ADDENDUM #2

DATE: July 10, 2024
TO: All Bidders
FROM: Donald R. Ernat
SECTION: 24-14865-00-DR, Grand Rapids Township

GENERAL PLAN & ELEVATION
E 21ST ROAD OVER
TRIBUTARY OF COVEL CREEK
SECTION 24-14865-00-DR
EXISTING S.N. N/A
PROPOSED S.N. N/A
GRAND RAPIDS TOWNSHIP

SHEET NO.
8 of 10

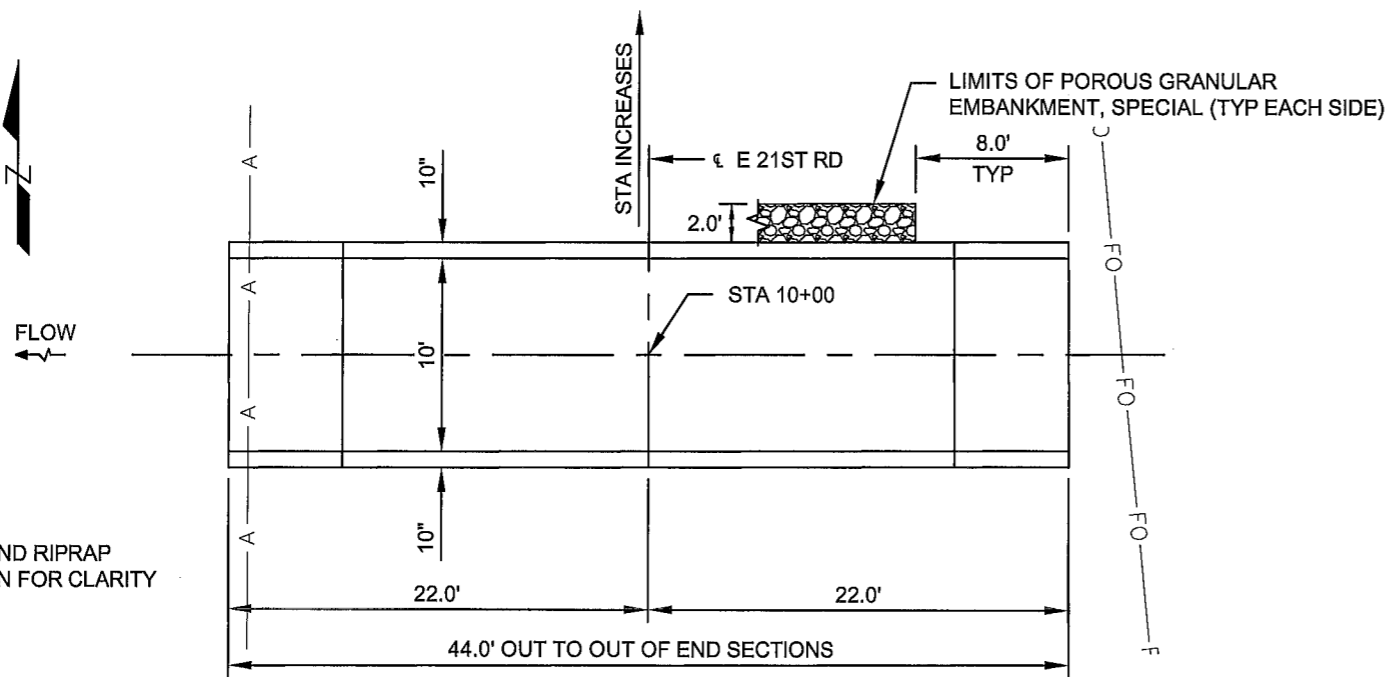
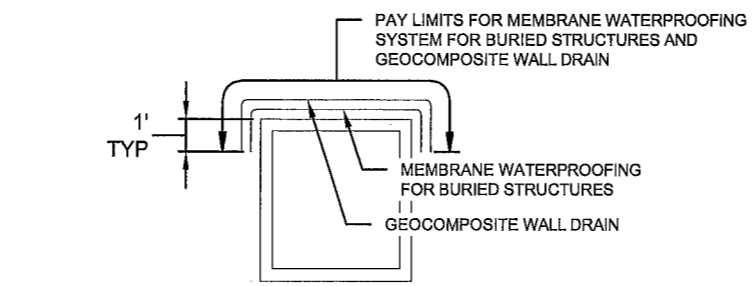
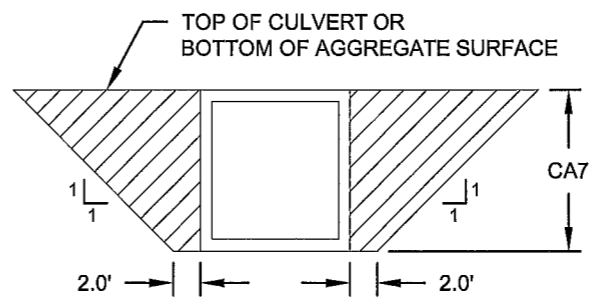
1. Remove page 4 of the Proposal, two Notice to Bidders pages were included, the 2nd page is incorrect (under Proposed Improvement states 10'x9' proposed culvert) and should be removed. The sheet was mistakenly included.
2. Replace page 1 of the Special Provisions with the attached REVISED. In the Description of Proposed Improvement, the precast concrete box culvert size was incorrect.
3. Replace Plan Sheet 8 of 10 with the attached REVISED. The precast concrete box culverts pay item is incorrect.

ITEM	UNIT	TOTAL
REMOVAL OF EXISTING STRUCTURES	EACH	1
STRUCTURE EXCAVATION	CU YD	360
BOX CULVERT END SECTIONS, CULVERT NO. 1	EACH	2
PRECAST CONCRETE BOX CULVERTS 10' X 10'	FOOT	32
GEOCOMPOSITE WALL DRAIN	SQ YD	49
MEMBRANE WATERPROOFING SYSTEM FOR BURIED STRUCTURES	SQ YD	49
POROUS GRANULAR EMBANKMENT, SPECIAL	CU YD	233
